## 5.8. RECONFIGURING A LOT - 2 ANDREWS STREET NEWELL BEACH

<b>REPORT AUTHOR</b>	Neil Beck, Team Leader Planning
<b>MANAGER</b>	Paul Hoyer, Manager Environment and Planning
<b>DEPARTMENT</b>	Environment and Planning
<b>APPLICATION NO</b>	ROL 2021_4160/1
<b>PROPOSAL</b>	Reconfiguring a Lot (1 lot into 22 lots)
<b>APPLICANT</b>	F R Coulthard & C B Coulthard C/- Brazier Motti Pty Ltd PO Box 1185 CAIRNS QLD 4870
<b>LOCATION</b>	2 Andrews Street NEWELL
<b>PROPERTY</b>	LOT: 51 SP: 168537 <b>PARCEL</b> 11485
<b>PLANNING SCHEME</b>	2018 Douglas Shire Council Planning Scheme Version 1.0
<b>ZONING</b>	Part Rural Zone Part Low Density Residential Zone
<b>LEVEL OF ASSESSMENT</b>	Code
<b>PROPERLY MADE DATE</b>	3 June 2021
<b>STATUTORY ASSESSMENT DEADLINE</b>	10 October 2022
<b>REFERRAL AGENCIES</b>	N/A

## RECOMMENDATION

**PROPOSED RECONFIGURATION (STAGE 2)**  
Lots 1-21 & Emts G & H in Lot 52  
Cancelling Lot 100 (Stage 1)

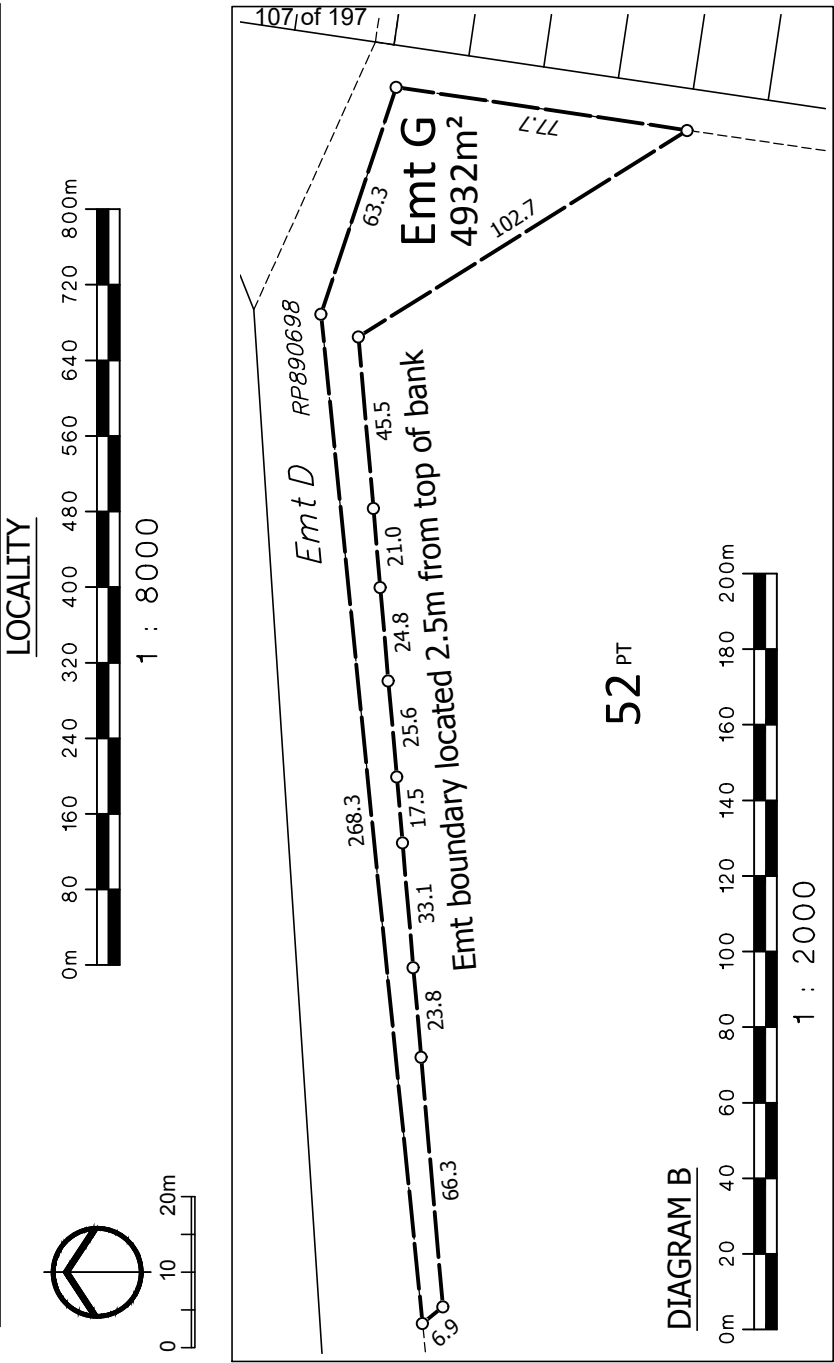
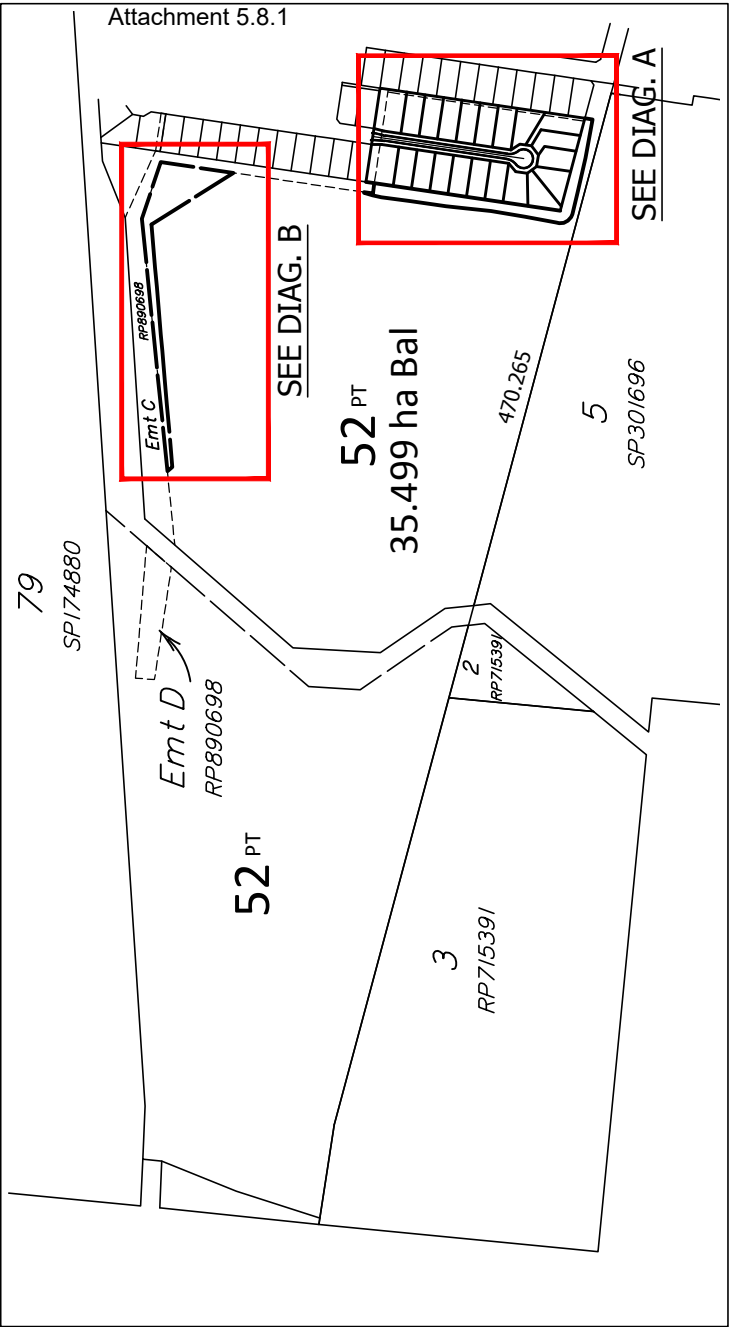
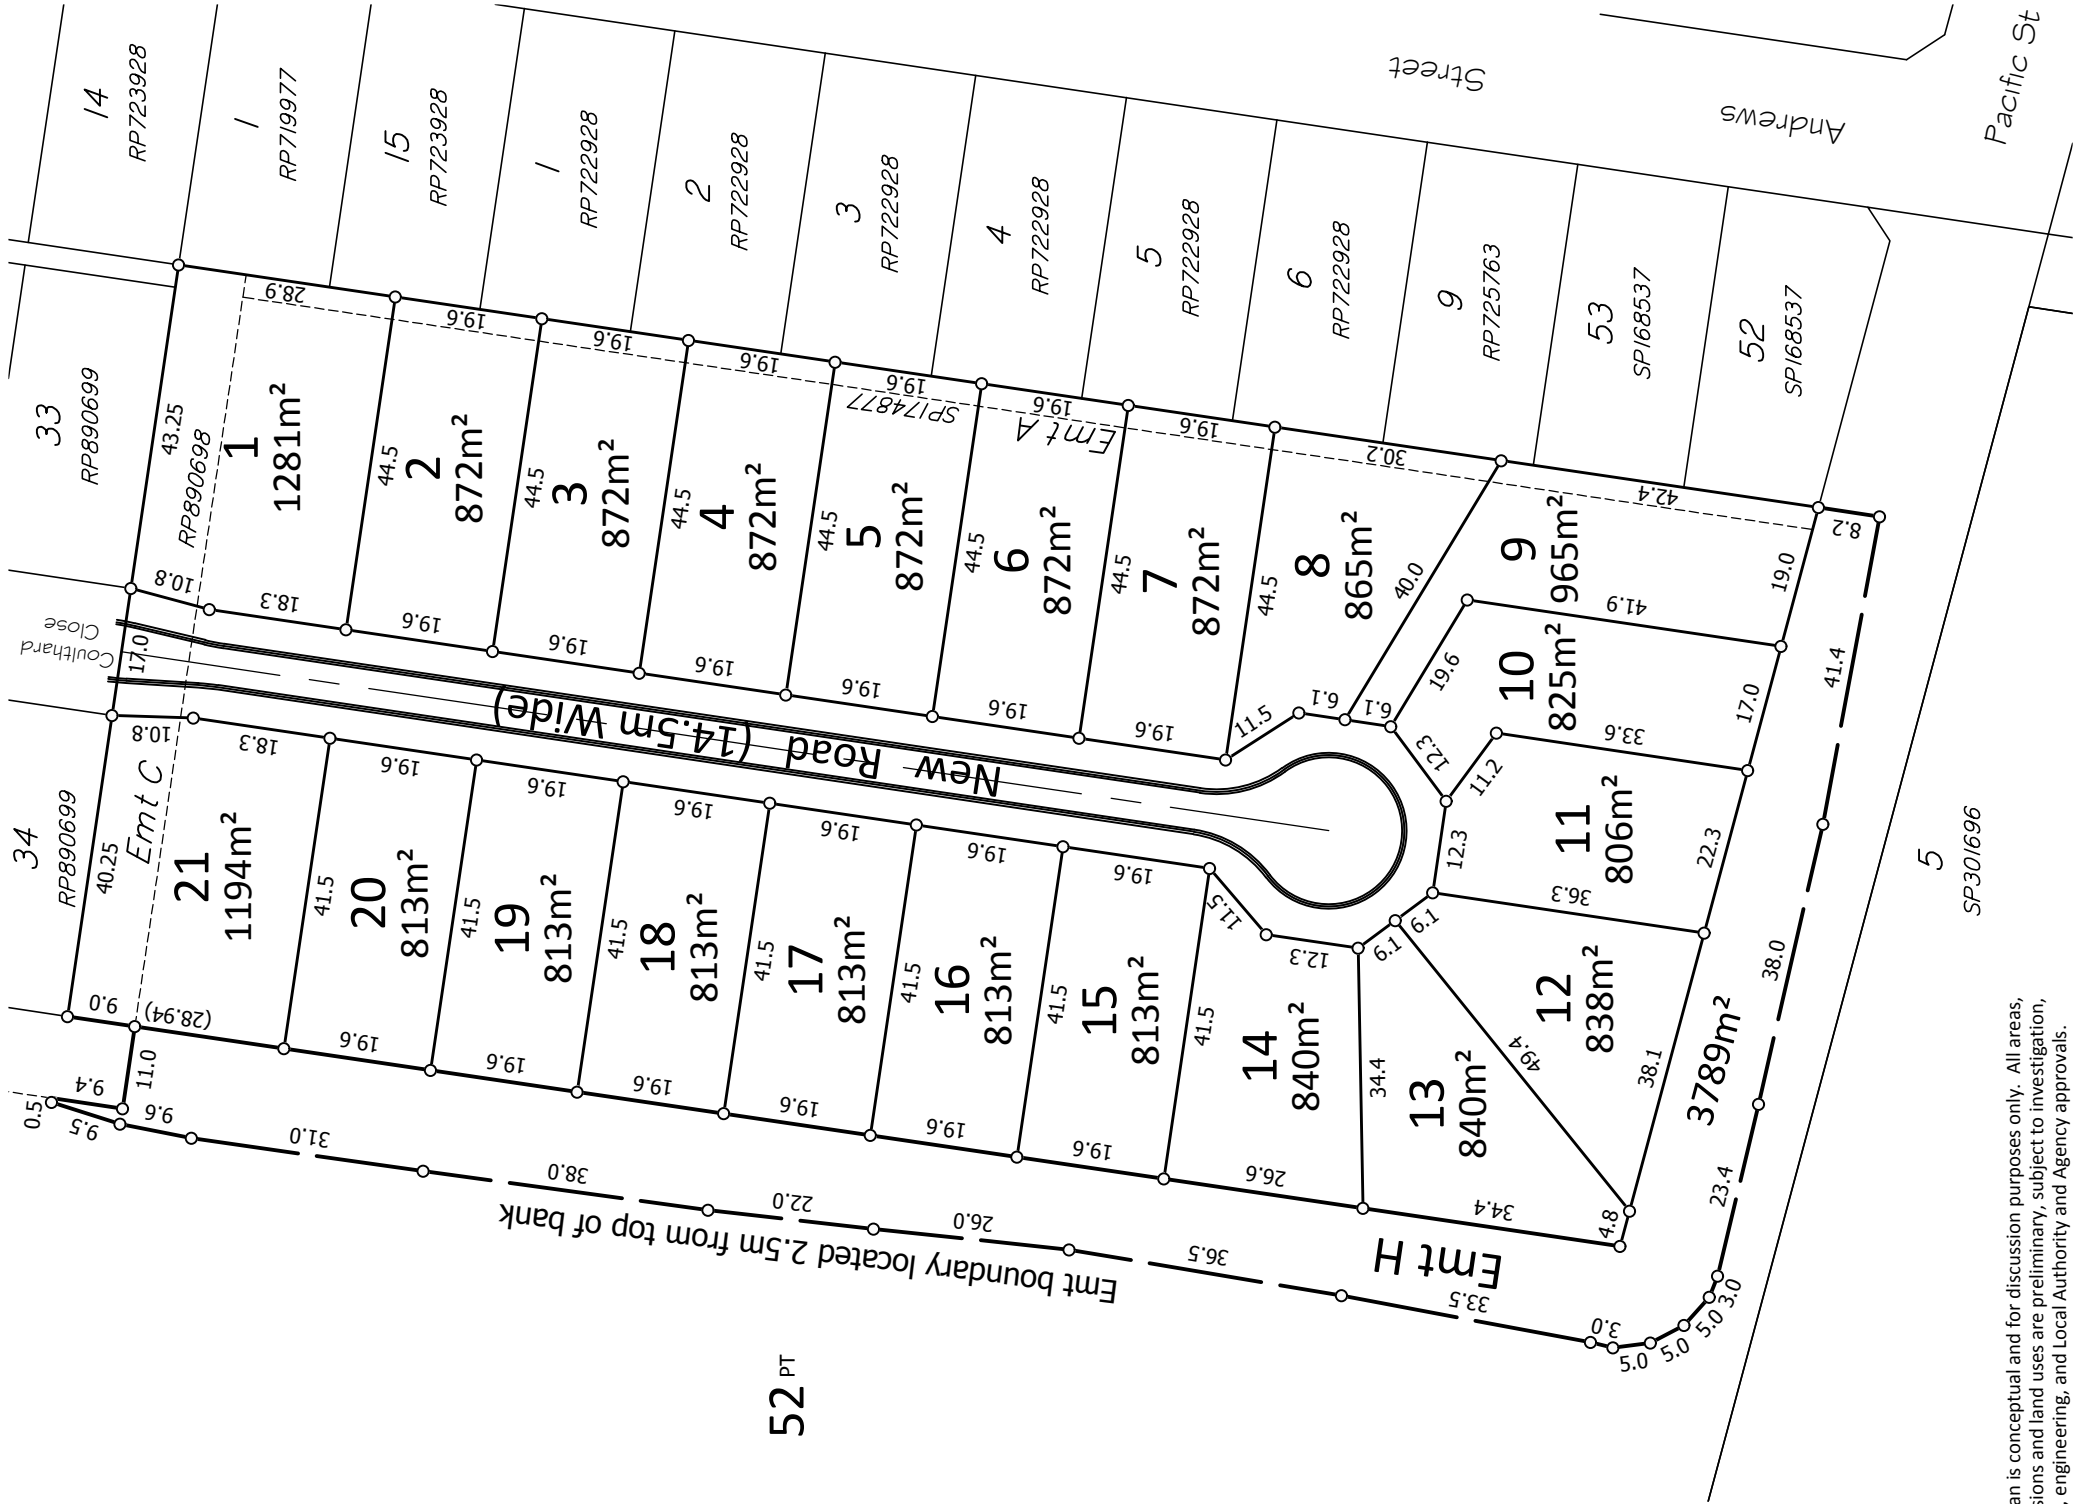
3. The lot layout plan must be revised and provided to the satisfaction of the Chief Executive Officer prior to the lodgement of the application for operational work, generally in accordance with the Brazier Motti Plan No. 34678/004 Issue C dated 19 August 2022 and amended to detail:
  - a. Allotments 8 – 13 to be reconfigured to provide less than 6 allotments to be endorsed by the Chief Executive Officer; and

- b. Provide a corridor to accommodate the water main to connect from Coulthard Close to Pacific Street as required by conditions of this Development Permit. The water main must be contained within an easement;

- ii. Conditions of approval require Lots 8-13 to be reconfigured into 4 allotments to increase the utility of the residential allotments and to meet the assessment benchmarks of the Low density residential zone with respect to minimum road frontage requirements and the ROL code with respect to number of allotments accessed via a cul-de-sac.**
